ECN/PCN No.: 4548

For Manufacturer			
Product Description: 32.768KHZ SMD LOW PROFILE CRYSTAL	Abracon Part Number / Part Series: ABS09	<input type="checkbox"/> Documentation only	<input checked="" type="checkbox"/> Series
		<input checked="" type="checkbox"/> ECN	<input type="checkbox"/> Part Number
Affected Revision: J	New Revision: K	<input type="checkbox"/> EOL	
		Application:	<input type="checkbox"/> Safety <input checked="" type="checkbox"/> Non-Safety

Prior to Change:

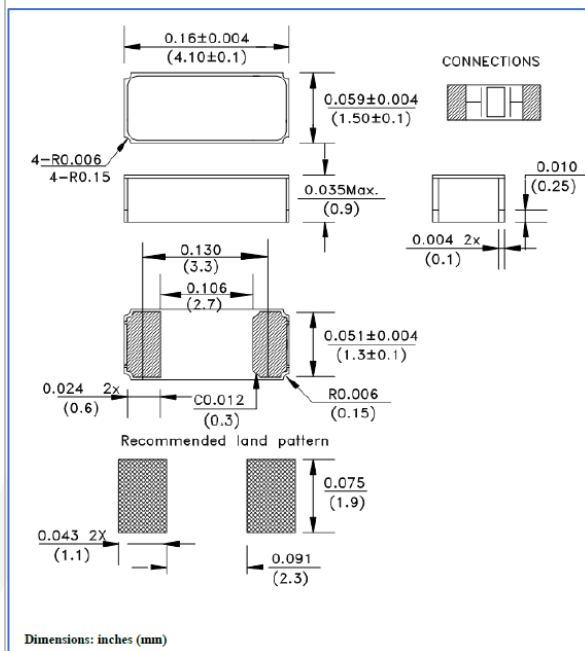
Abracon introduced additional manufacturing sources to ensure product availability and to be in a better position to meet long term customer demand. Added an alternative bottom packaging structure to reflect the product produced by all manufacturing sources.

The added bottom packaging structure does not impact the electrical performance of the device.
